To: Phil Tripp, Tripp Engineering
From: Pat O'Mahony, Associate Planner; 910-341-0189
CC: File;
Date: 5/21/2021
Re: Woodland Park Minor Subdivision TRC Rev. 3

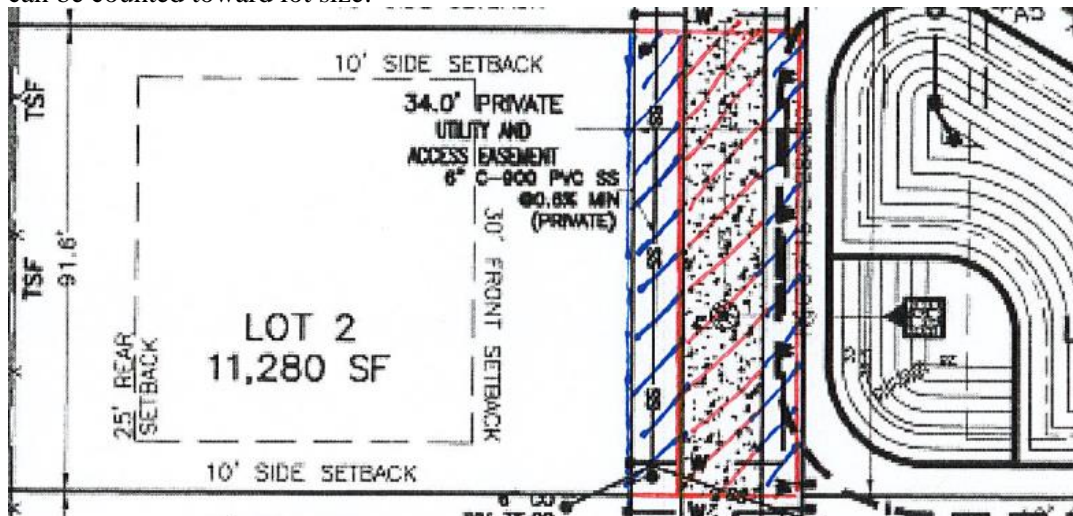
1. No issues with the easement lines being in the lots. Since it is an easement and not a right-of-way, the easement has to extend into the lots. I just wanted confirmation that the paved area within the easement was subtracted from the lot size and shown accurately on the plans. See example below. The hatched area is the easement and included as part of Lot 2. The area hatched in red is improved (paved) and must be subtracted from the lot size. The area in blue can be counted toward lot size.
